THE
BULLETIN
OF THE
EAUX-ARTS INSTITUTE OF DESIGN

DECEMBER • 1935

CONTENTS

SECOND MEDAL—G. CHAPMAN
CLASS A PROJET I—A POST OFFICE

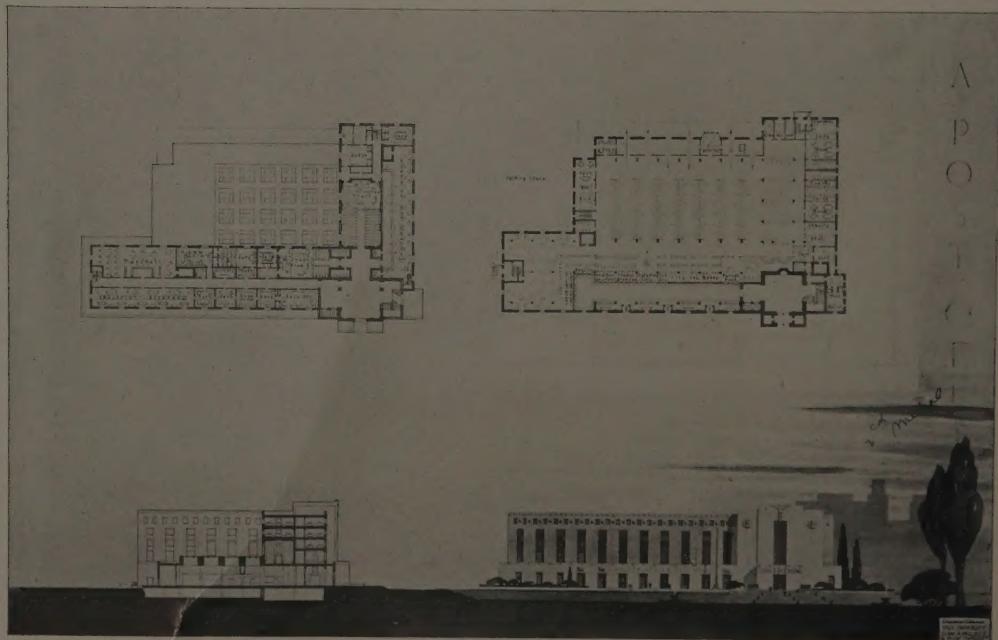
The solution offered by G. Chapman tells us of a certain degree of complexity in the building, true in the main. It loses coherence by singling out the top floor from a group of floors for special expression. An attempt is made to have only one vertical circulation for the whole building. That could probably be done, although the public space as shown is hardly adequate. There seems to be no advantage in having the Court Rooms together for the sake of the public, since the same public does not use both rooms, and it must, in order to reach a given spot traverse a certain distance either within the building or without.

SECOND MEDAL—W. S. ALLEN

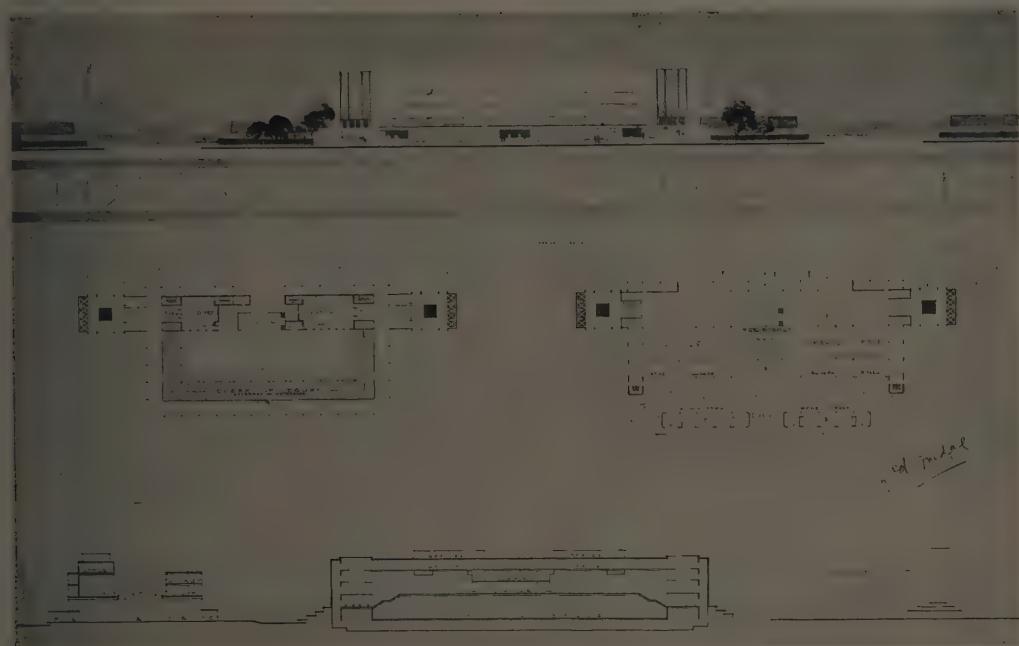
The projet of W. S. Allen minimizes the Post Office by putting it in a sort of basement storey, and separating it entirely from the circulation of the Courts and Offices. It is interesting to see, however, that the scheme has been carried out boldly and consistently.

HALF MENTION—P. AVITABILE
CLASS A PROJET I—A POST OFFICE

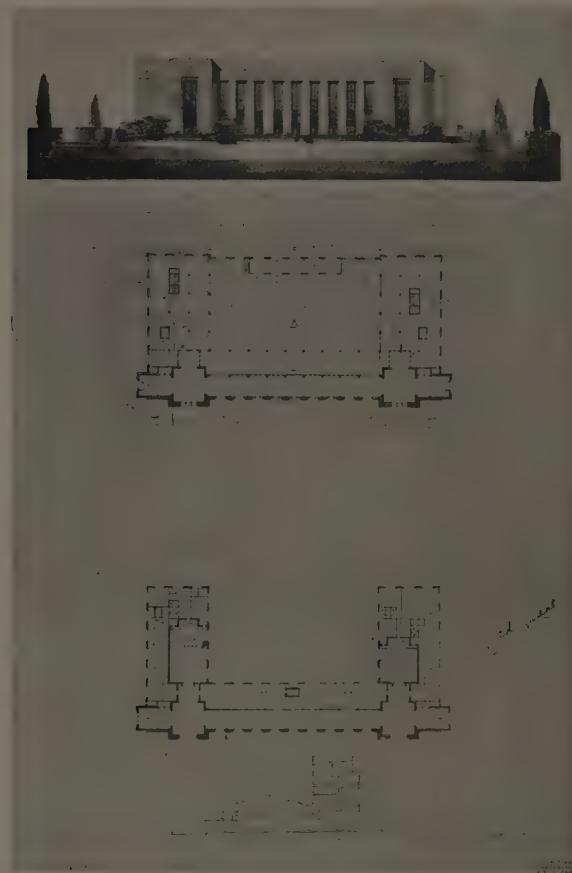
The Half Mention drawing illustrated fails in the three ways just enumerated. It is not expressive—of *this* Federal Building. The too simple facade conceals the important divisions instead of explaining them. It is not made up of real elements, witness the spans for the work room, and the poche at the Post Office vestibule.

And it is not composed—no attempt has been made to coordinate the front and side facades. Yet the workable scheme is a good one. The disposition of the elements, and the major and minor circulations have been intelligently worked out. It is even possible for the workers to change to their overalls in the basement under supervision. That is an interesting and perhaps necessary fact, but it is not architecture. It is only one of the things with which a designer contends as he tries to compose expressive designs out of the elements of buildings. This drawing is not alone in these failures. On the contrary, it illustrates what was commonly found to be true throughout the problems.

EMERSON PRIZE AND FIRST MEDAL—A. C. JOHNSON
EMERSON PRIZE—THE ENTRANCE TO AN IMPORTANT BUILDING

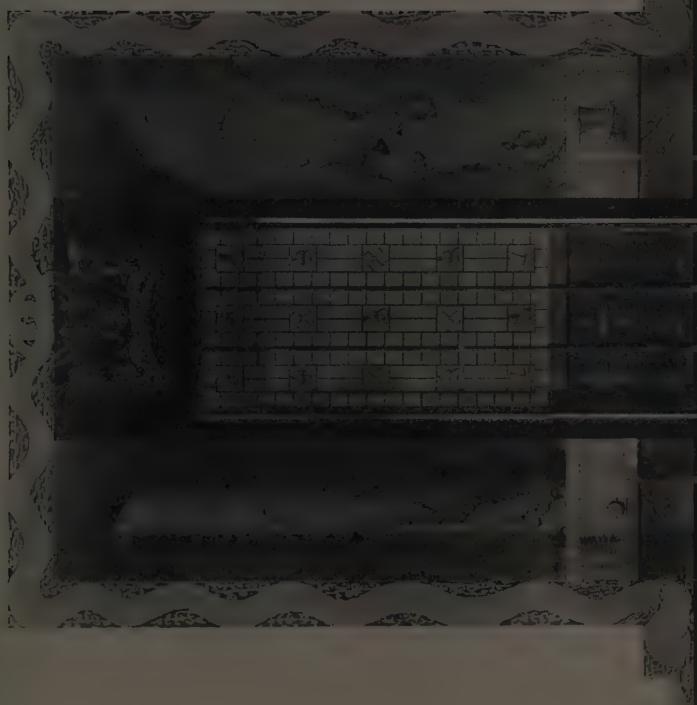
The Emerson Prize was awarded to A. C. Johnson on the expression of the horizontal entrance echoing the low first storey, the excellent interpretation of the contemporary architecture of Holland, and the consistent expression of the character of the building and its entrance. The rendering of the brick work is a feat of realism, so perfect was the gray pink color and texture. The granite base and piers were of a lighter shade of the same color. The design of the ornament was questioned as to its dignity in representing the country, being perhaps more applicable to a Dutch tavern. However the design was done with sincerity. The show windows of the first floor are inadequate for commercial use. The section is not complete so the jury interpreted the high second storey to be display space.

FIRST MEDAL.—M. O. URBAIN
EMERSON PRIZE.—THE ENTRANCE TO AN IMPORTANT BUILDING

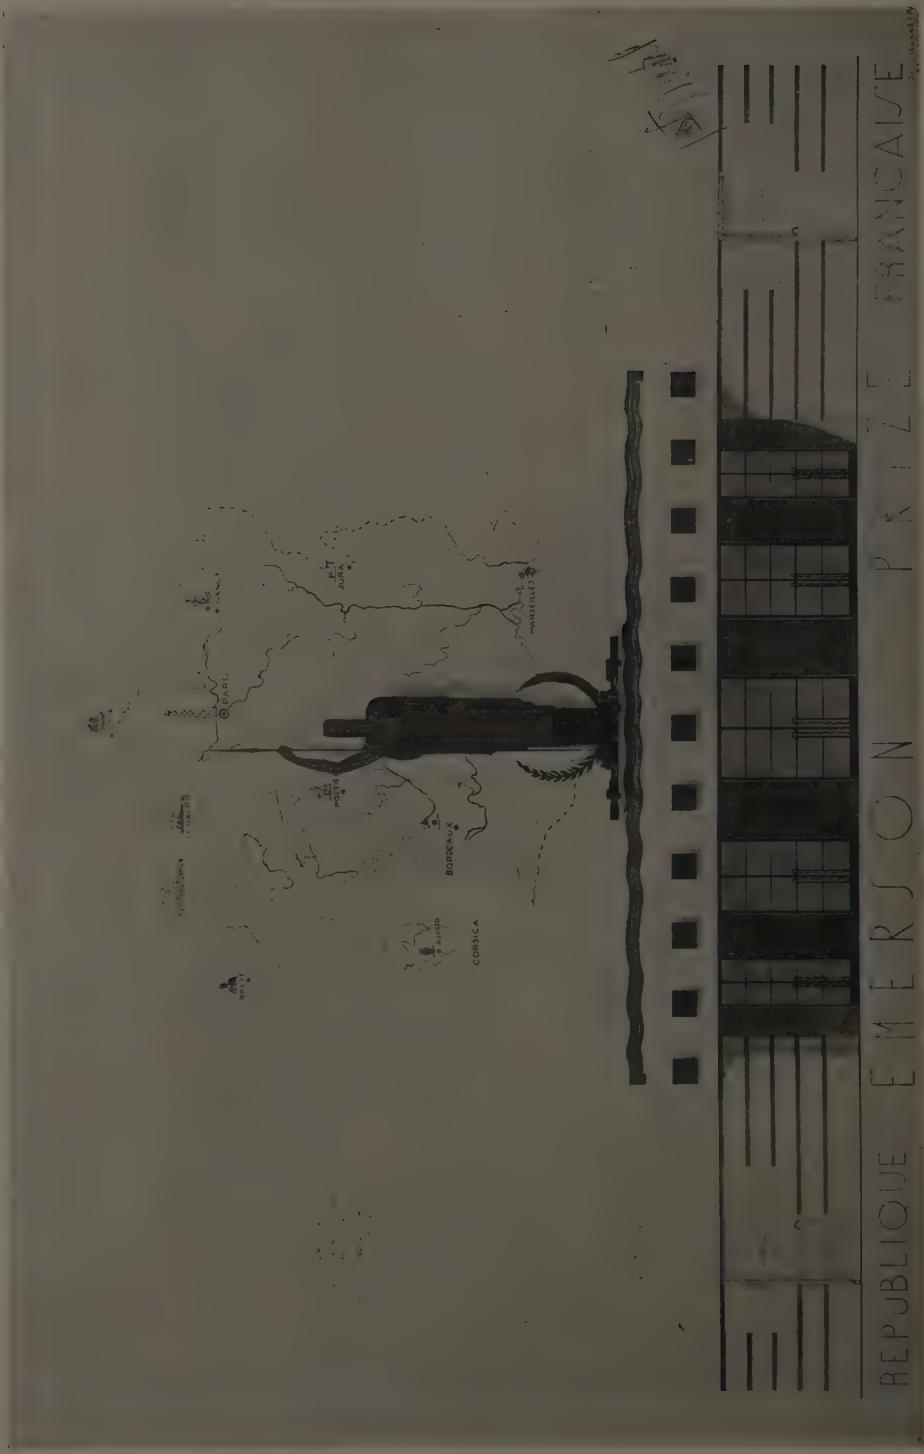
The solution presented by M. O. Urbahn was highly commended as an excellent modern interpretation of Chinese design. The materials used were green and gold mosaic, black marble, with bronze doors and window frames. The drawing of the complete building was sacrificially outlined to make the sheet composition better. The section clearly shows a great hall three storeys high, which the entrance expresses. This design was awarded a First Medal.
